Coastal Access – Felixstowe Ferry to Bawdsey

Representations on Lengths FFB1, FFB4, FFB5 and FFB6

March 2022

Figure 1: Map showing possible locations for speed bumps

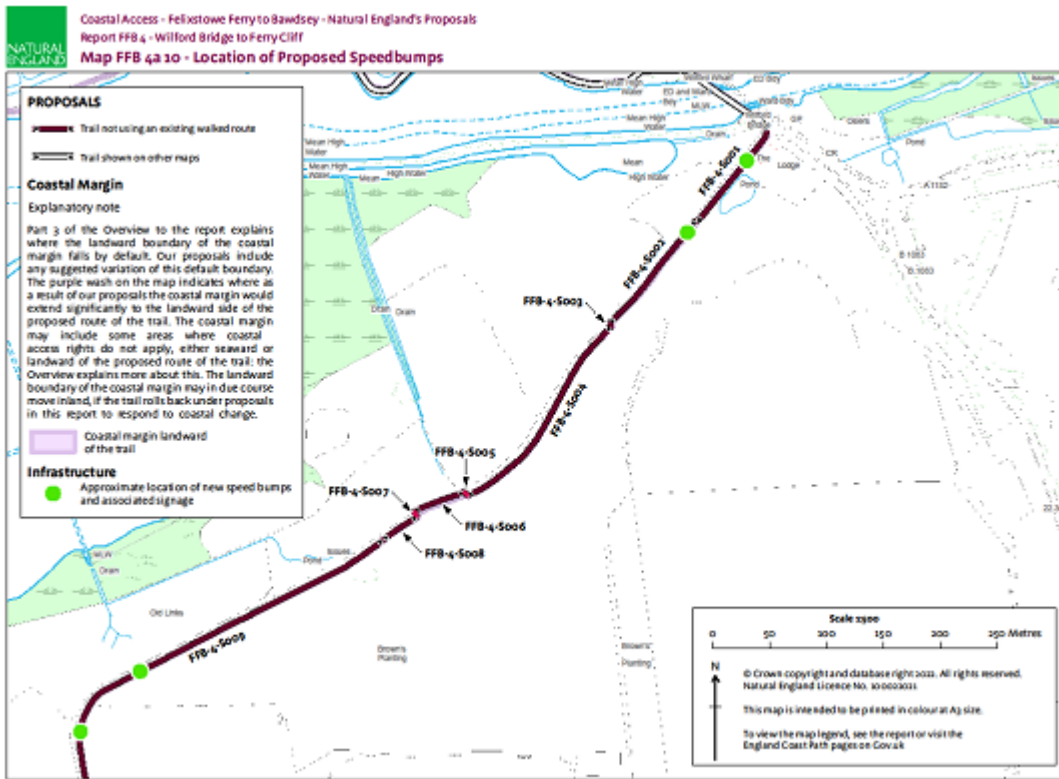
We acknowledge that there is a bend on route section FFB-4-S009 and here we propose the trail would follow the landward verge. In addition to this in our comments on the 2 objections Natural England received on Coastal Access Report FFB 4, we also advised the Secretary of State that we would be happy to work with the NT as landowner, to investigate if speed bumps could be installed on route sections FFB-4-S009 to ensure drivers maintain a slow speed if this would give more confidence to residents and walkers using the track here. This is shown in the map in Figure 1 below.

Some users may still opt to use the track as opposed to the verge, because it provides a firm tarmacked surface. They will have a legal right to do this because TLT will fall into the accessible coastal margin either by default under the legislation where it falls seaward of the proposed route or because we have used our discretion under the Act to propose that the landward boundary of the coastal margin is the landward edge of TLT. We will however ensure the verge is clearly waymarked as the trail so walkers using the track will be able to move aside from any traffic as needed. In addition to this we propose to install clear signs ensuring all users are aware of the 15mph advisory speed limit and that the track is shared by both drivers and pedestrians. These signs will be maintained by Suffolk County Council with grant support from Natural England. Taken together we believe that our proposals will deliver an improvement on the current situation for walkers on the TLT.

Road Safety Assessment: Suffolk County Council

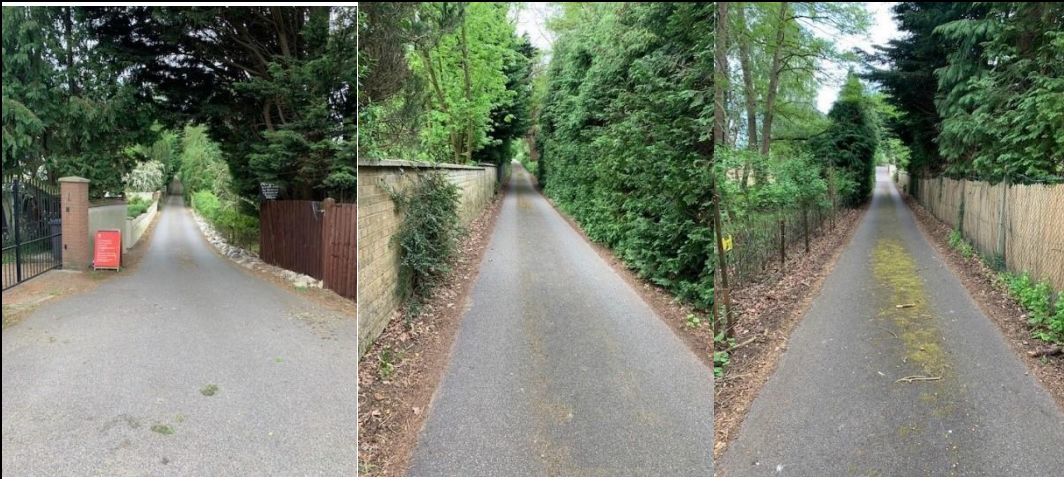
We are sorry [redacted] finds it difficult to establish the brief of the Road safety Assessment undertaken by Suffolk County Council. We can confirm that it was to seek [redacted] expert opinion in his role as Principle Highways Engineer at SCC on whether the track from its entrance adjacent to The Lodge to Dairy Farm is a safe route on which to align the England Coast Path National Trail. He was also asked to identify why it would be safe or unsafe, and if some sections were unsafe, to advise us what work could be done to make these sections safe.

We note that [redacted] does not agree with the conclusions drawn by [redacted] however we do not propose to comment on his critique of SCC's safety report, because [redacted] is the Principle Highways Engineer at SCC and as such is the recognised specialist to which we should adhere.

Figure 1: Map showing location of proposed speed bumps

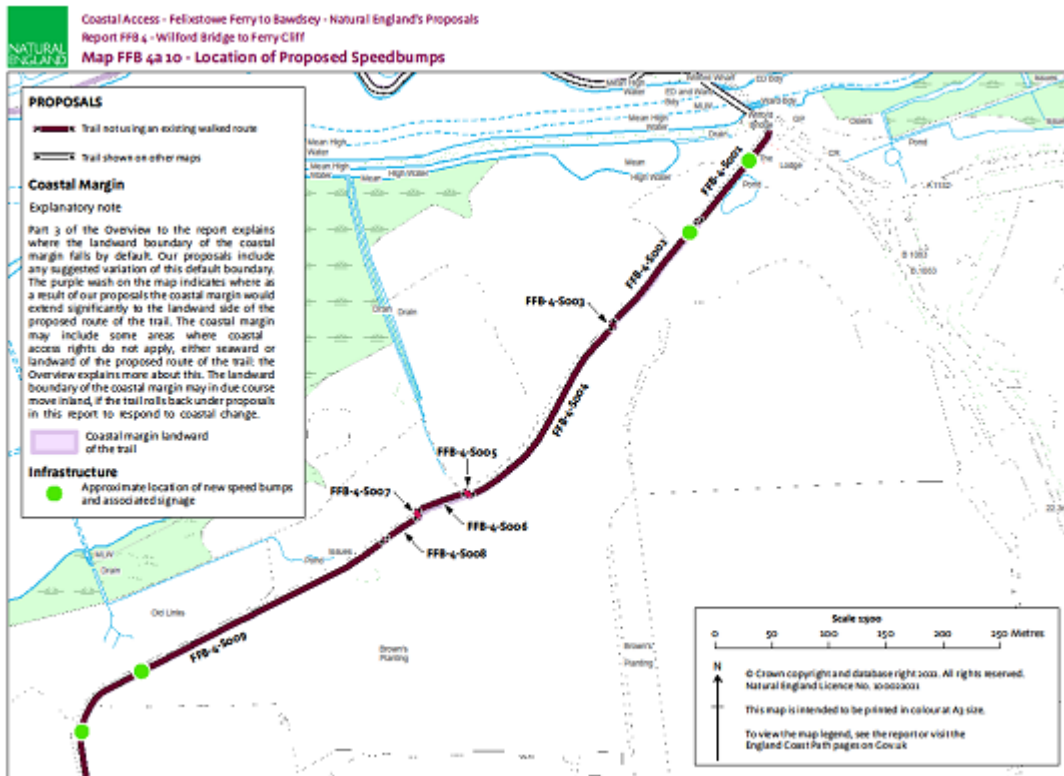
[redacted] identifies hazards not reported in the Suffolk CC safety report on TLT which are covered in the Bullard Report. Including blind corners, sun dazzle and the lack of an estimate of the numbers of walkers or vehicles likely to use the track. She also asserts that the report does not comply with GG119 Road Safety Audit for Highways. We address these issues in turn below.

We agree there is a blind corner on TLT on route section FFB-4-S009. Here Suffolk CC's safety report identifies that there is adequate space either side of the track for walkers to step onto should the need arise and space for a parallel route to be created. We have therefore proposed that route section FFB-4-S009 follows the verge on the landward side of the track. NE have also stated in our comments on objections that we would be happy to investigate if speed bumps could be installed on TLT to ensure drivers maintain a slow speed, if this would give more confidence to residents and walkers using the track. The map at Figure 1 below shows 4 proposed locations for these which we feel would be worthwhile exploring further. Two are either side of the bend on route section FFB-4-S009.

Exhibit 2

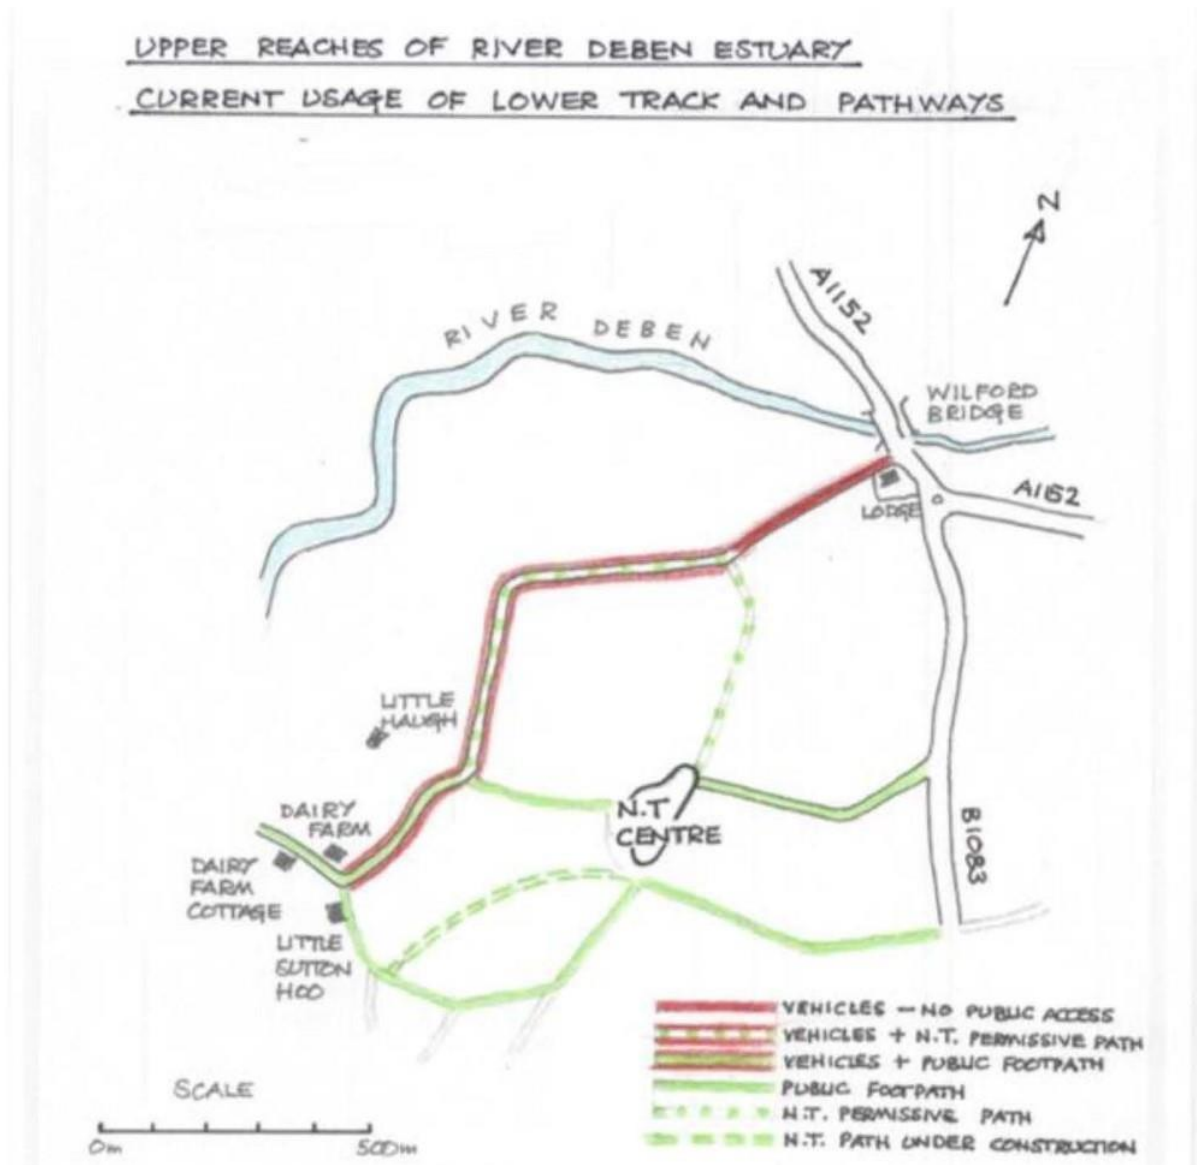
A plan of the Sutton Hoo section of the Deben estuary, as it is today, is below – Exhibit 2 with a larger version in Appendices. It shows the Lower Track, currently divided into 3 sections: (i) public footpath; (ii) NT permissive track; (iii) private – no public right of way. It also shows adjoining public footpaths, NT Permissive Paths and the new NT path about to be constructed.

Picture 1

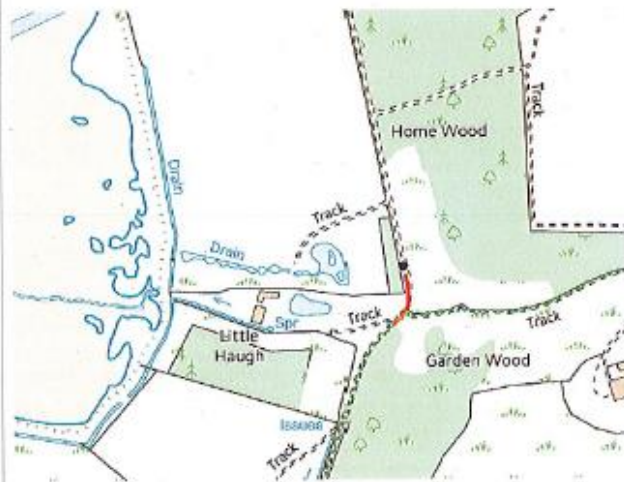
The first bend (Picture 1) was found to have reasonable sightlines, with vegetation allowing approaching vehicles to be seen for some distance. It was also observed that there is room for pedestrians to step to one (east) side so cars can pass on this section.

Picture 4. Walkers stepping aside as a vehicle passes plus advisory 15mph sign.

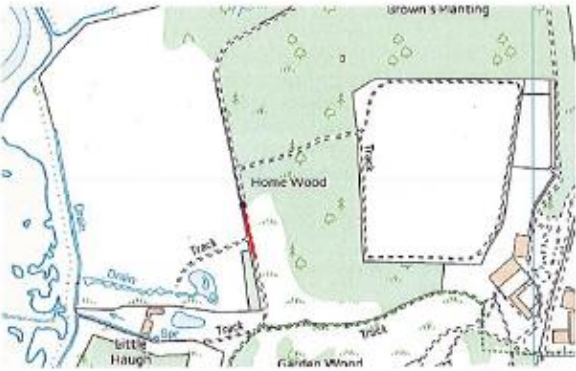
It was found that there was adequate space on this section to create a parallel path on the verge/ woodland to link the two bends (the second bend already has a parallel path created) should this be deemed necessary. Vegetation needs cutting back in places.

Picture 6. Close to where the permissive route joins the track from the woods.

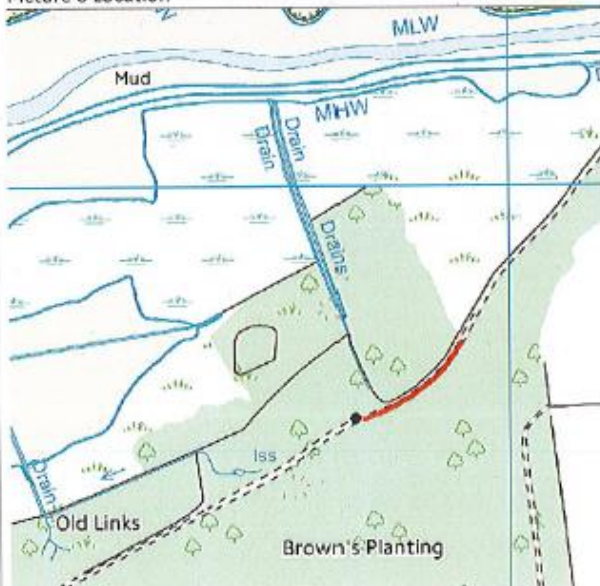
It was found that this section has adequate space either side of the track for walkers to step onto should the need arise, with space for a parallel route to be created should this be deemed desirable by Natural England and the National Trust (see map on page 9).

Picture 7. Warning sign to make drivers aware of the presence of pedestrians

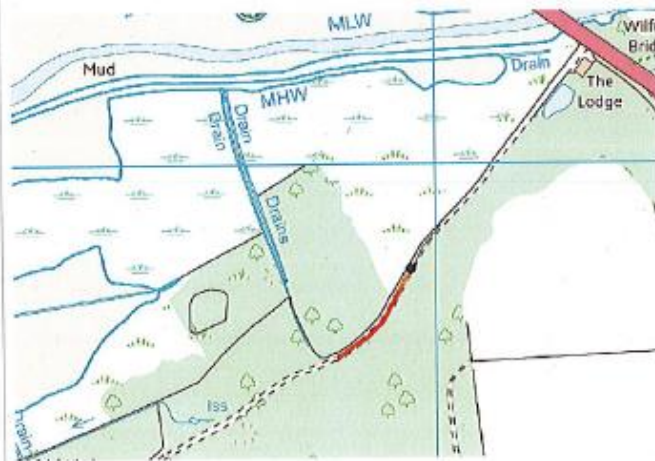
Beyond this point, towards the Lodge, the route is not permissible (approximately 350m). It was found that the nature of the slope on the east side of the track would make it difficult to create a parallel route here, but it would be possible on the west side with some cutting back of vegetation and nettles in particular. The map (below) illustrates this, and identifies where it would be relatively straightforward to create a parallel path to the track.
